Planning Application: P/23/0053 – Dragon Parc, Coal Authority Consultation Response

Figure 5: Mining Risk Zones and Mitigation Plan

Project: Land at Dragon Parc, Abercanaid, Merthyr Tydfil

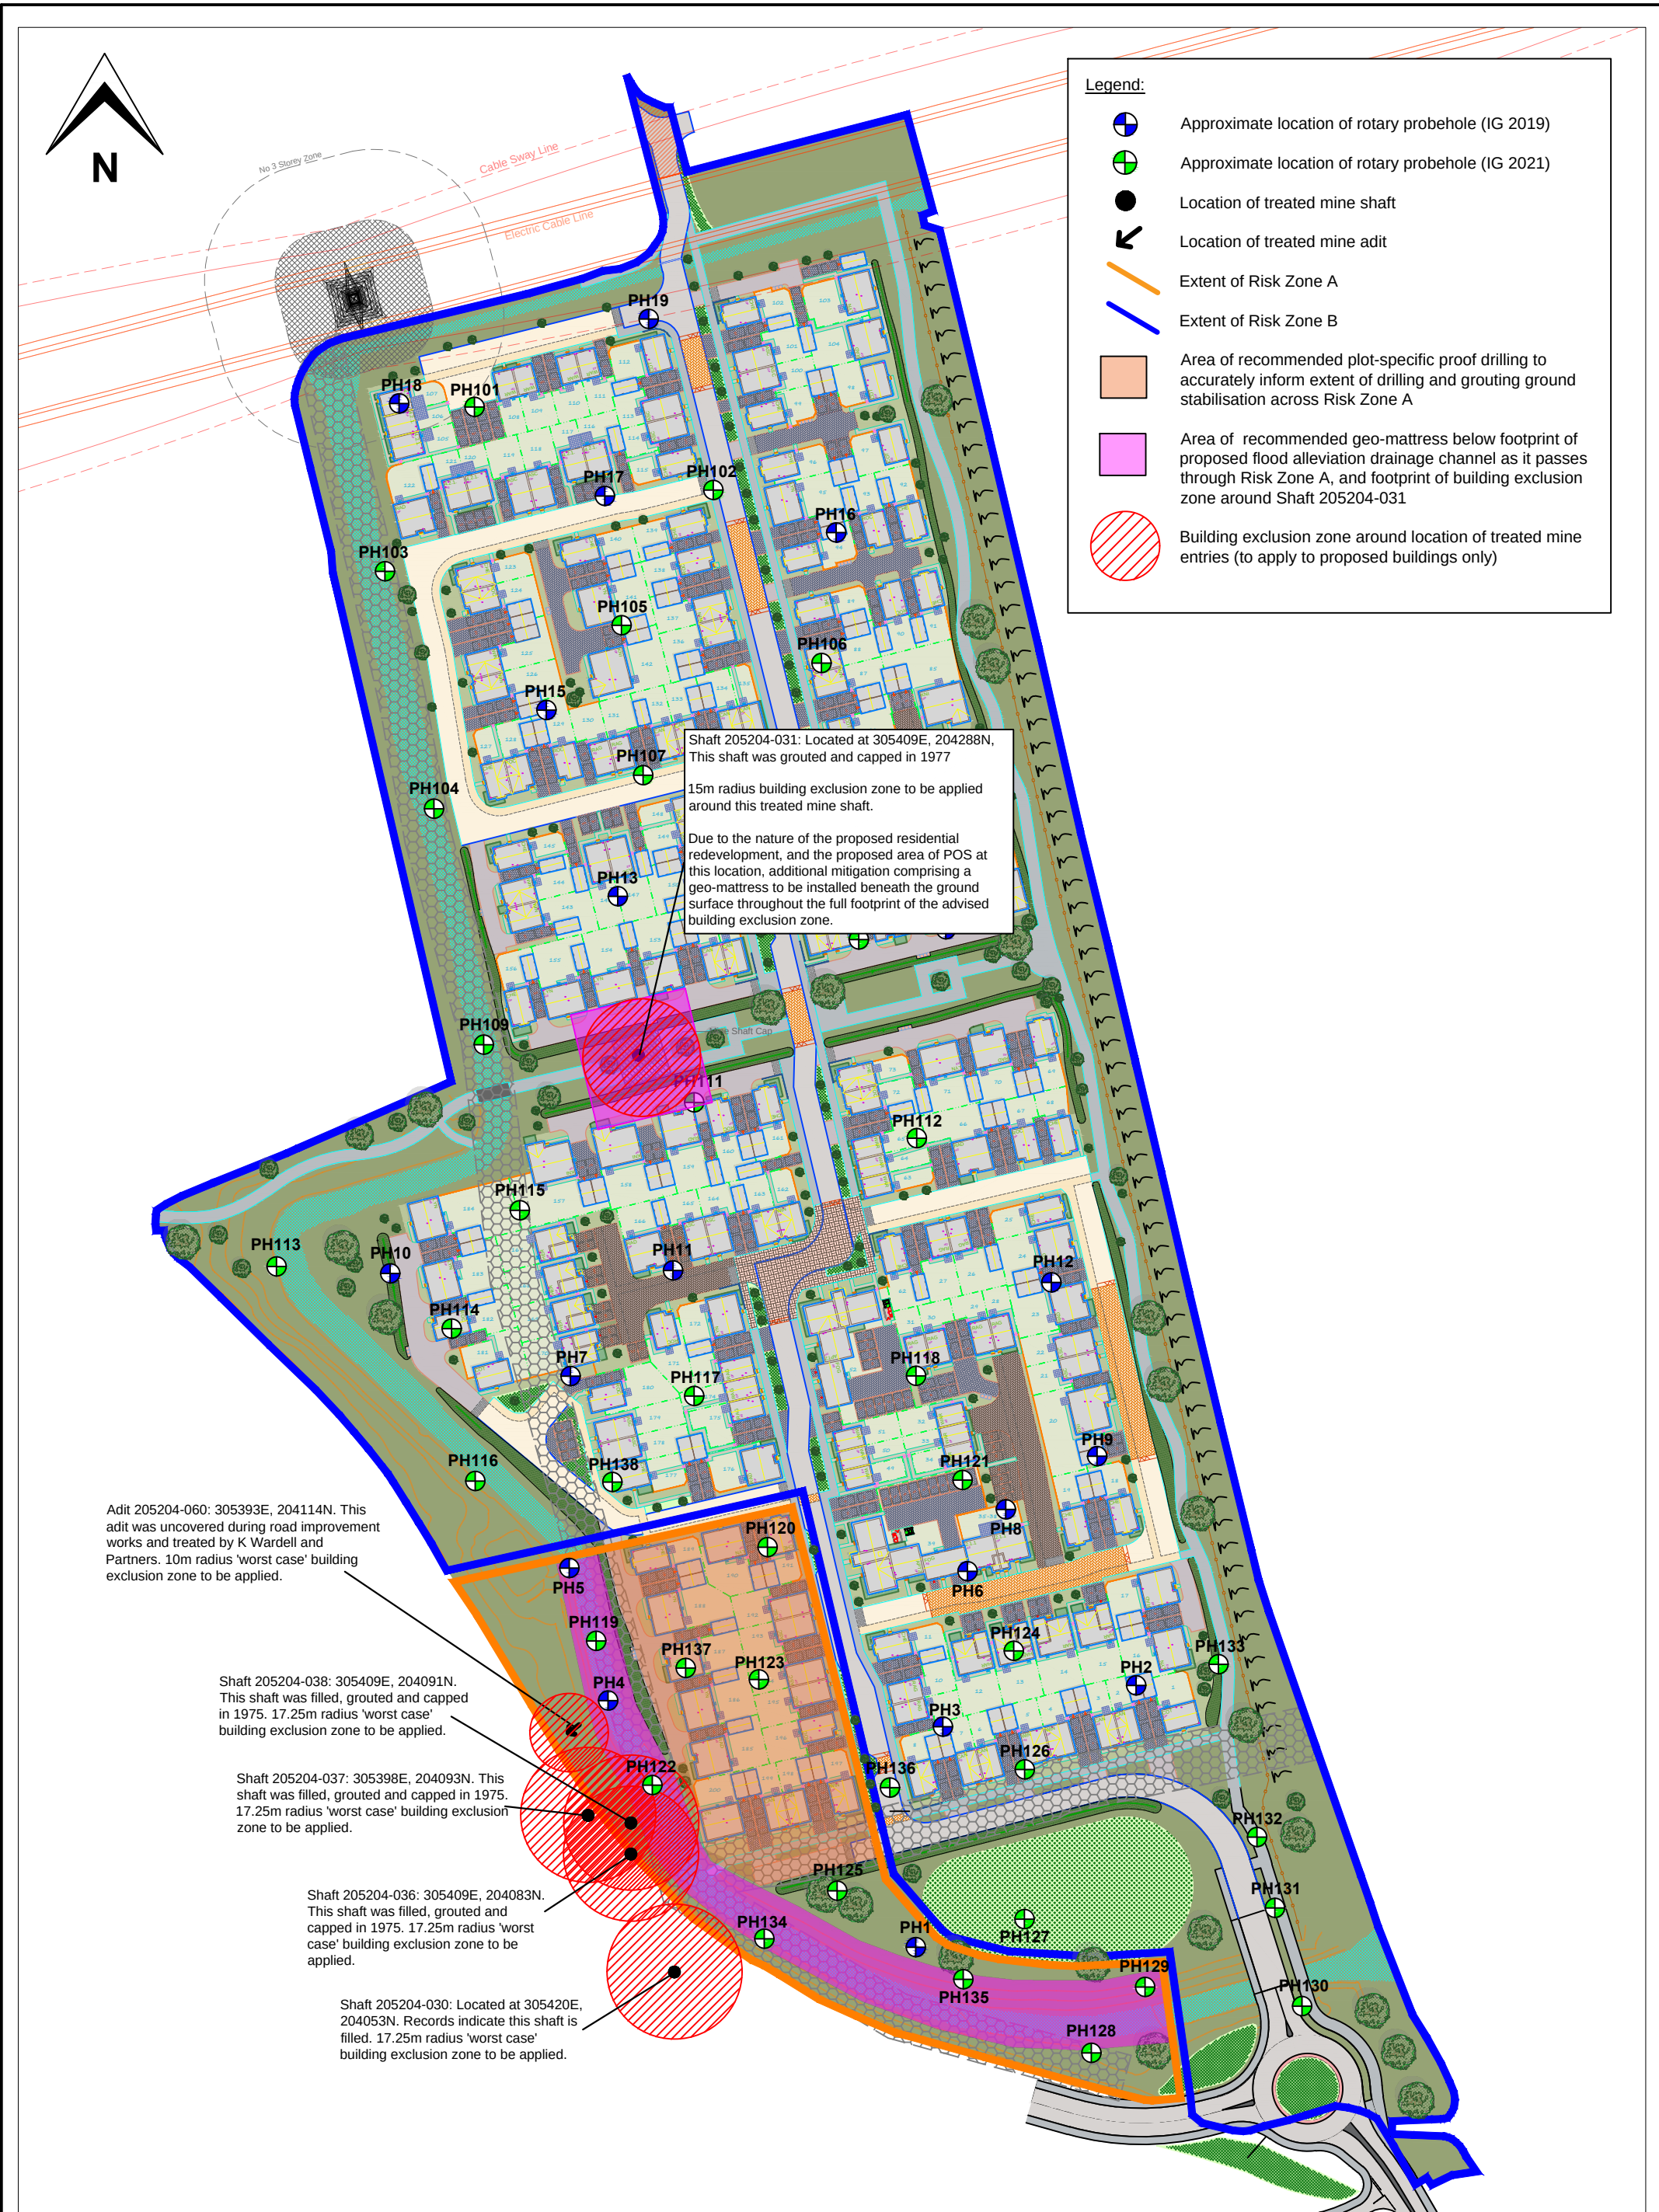
- *“Regarding the mine shafts on the site the report author’s state that shaft 031 was located during the bulk excavation works and the shaft was capped at a depth of 10m below ground level. They note that the shaft cap was intact and spanned an area of 10m x 10m. Although the report authors have noted that the shaft cap was intact, they make no assessment in the report as to its suitability for the development now proposed. The stand-off from this feature proposed as part of the development layout is noted. It would be appreciated if the report authors could provide further commentary on the suitability of the shaft treatment works in respect of the current development proposals.”*

- *“The report authors note that mine entries 038, 036, 037, 060 and 030 have all been previously located and treated. Figure 5 in the report identifies the ‘as recorded’ locations of the mine entries and their zones of influence. This is apart from 060, which is an adit, and which the report authors have concluded poses no risk. However, it is not clear if this plan annotation takes account of the potential plotting errors for these features which are still noted on our records as having potential departures from their recorded positions. Further commentary on this issue would be appreciated, along with any revised plan necessary to take account of the potential departures for these features from their recorded positions.”*

It is understood that the Coal Authority are querying the size of the recommended building exclusion zones around these features because of perceived positional uncertainty regarding their locations.

The size of the advised building exclusion zone around Shaft 031 is considered appropriate for the following reasons:

- (1) The shaft has been treated by grouting (as such the potential risk of the treated backfill slumping is considered low).
- (2) A significant concrete cap was constructed over the grouted shaft (10m x 10m).
- (3) The concrete cap was observed to be intact and in good condition and constructed in competent natural strata (considered to represent weathered bedrock).
- (4) Additional protection to the proposed buildings (situated outside the building exclusion zone) will be provided by the proposed site-wide re-engineering earthworks.
- (5) Additional protection to the proposed buildings (situated outside the building exclusion zone) will be provided by the specified foundation reinforcement criteria (all foundations to be designed to span a 3m lack of support).
- (6) No additional foundation loads will be transmitted through the treated shaft.

However, due to the nature of the proposed residential development in the vicinity of the shaft (i.e., footpaths, POS etc.) and considering the comments from the Coal authority, additional mitigation comprising a reinforced geo-mattress (at proposed ground level) throughout the full footprint of the building exclusion zone around Shaft 031 is also proposed (see attached plan).

This query relates to several mine entries near the south-western site boundary (see Shaft 038, Shaft 036, Shaft 037, Shaft 030, and Adit 60 on the attached plan).

The size of the 'worst case' building exclusion zones around Shaft 038, Shaft 036, Shaft 037, Shaft 030 have been revisited following a review of the comments from the Coal Authority (see revised plan attached).

As shown in the attached plan, for Shaft 038, -036, Shaft 205204-037, and Shaft 205204-030, revised building exclusion zone radii of 17.25m has been applied. The size of the shaft exclusion zones are based on the following factors: an assumed shaft radius of 1.25m (based on the assumed 2.5m diameter detailed on the online CA viewer), a 5m radius Coal Authority plotting departure distance (based on the departure distances detailed on CA viewer), and a depth to bedrock of approximately 11m (based on the average depth to bedrock recorded at the two nearest boreholes – BH122 and BH134).

In addition to the above, a 10m radius building exclusion zone has also been applied around Adit 60 to account for the 10m Coal Authority assigned departure distance for this feature.

Additionally, a geo-matress is to be installed throughout the full footprint of the proposed drainage channel as it passes through Risk Zone A.
